PULLEY DIAMETER CHANGE

LEA0090

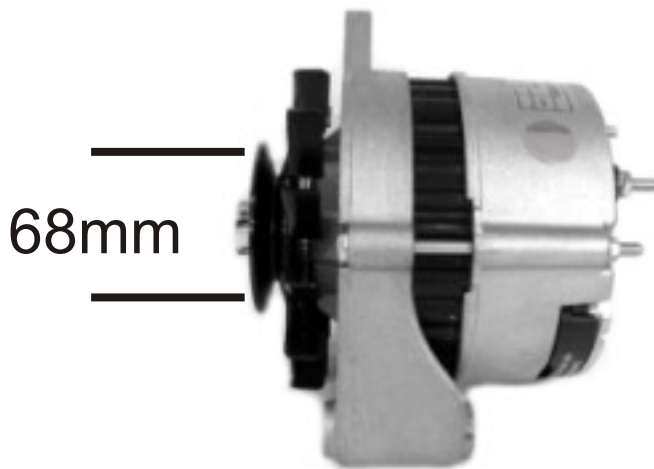
Pulley dia changed
from Ø78 to Ø68
According to **ISKRA IA0446**

LEA0092

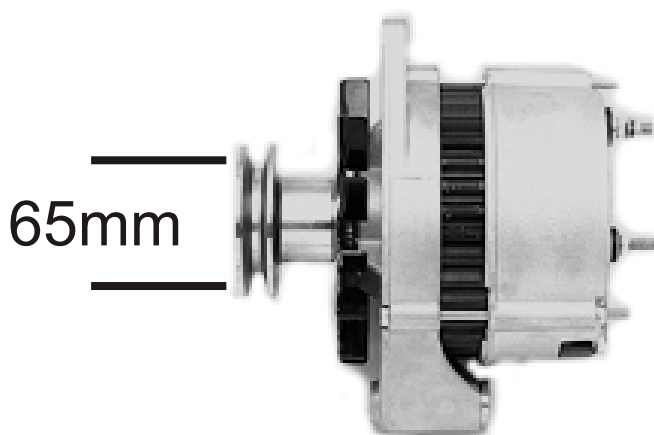
Pulley dia changed
from Ø72 to Ø65
According to **ISKRA IA0220**
